SERVICE ACTION

Reference number:	SA-10-1127V3	Issued: 23 November, 2018
Subject:	Fuel Filler Latch	
Model(s):	Vantage 19MY	
VIN range:	Refer to the separately published list of Vehicle Identification Numbers (VINs)	
Applicable to:	All Dealers	
Distribute to:	After Sales Manager Executive Manager Service Manager Sales Manager	Warranty Staff Technician(s) Parts Staff

Figure 2

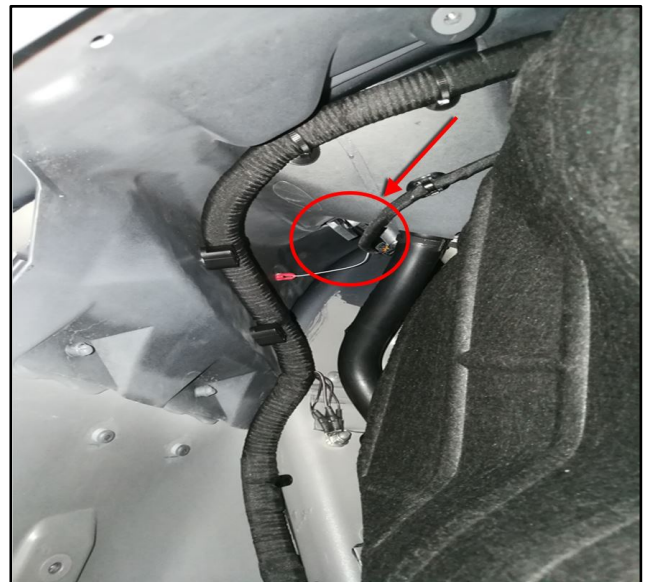
Aston Martin has found that the fuel filler latch mechanism can move out of position. If the fuel filler latch is not in the correct position the fuel filler door will not open or close correctly.

1. Remove the rear right-side wheel-arch liner (refer to Workshop Manual procedure 01.08.AK).
2. Remove the fuel filler latch from the clips that attach it to the vehicle body (refer to Figure 2).

Figure 3

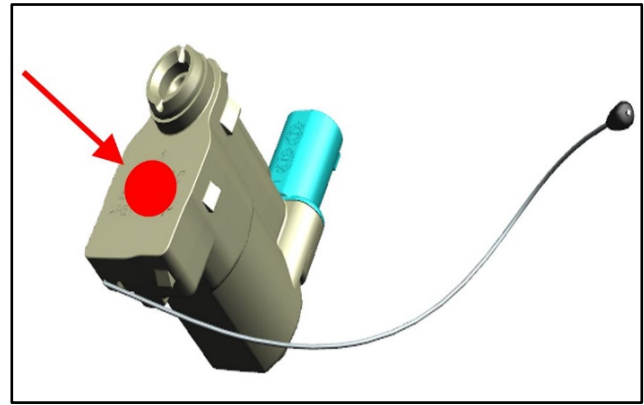
3. Apply Plexus MA300 adhesive in the location shown by the red dot (refer to Figure 3).

4. Install the fuel filler latch into the clips that attach it to the vehicle.
Note: Make sure that you hear a “click” sound as the fuel filler latch engages into position.
5. Keep the fuel filler door open for a minimum of fifteen minutes while the Plexus adhesive cures.
CAUTION: IF YOU DO NOT GIVE THE PLEXUS ADHESIVE TIME TO CURE, THE FILLER LATCH MAY NOT BE INSTALLED CORRECTLY.
6. Install the rear right-side wheel-arch liner (refer to Workshop Manual procedure 01.08.AK).
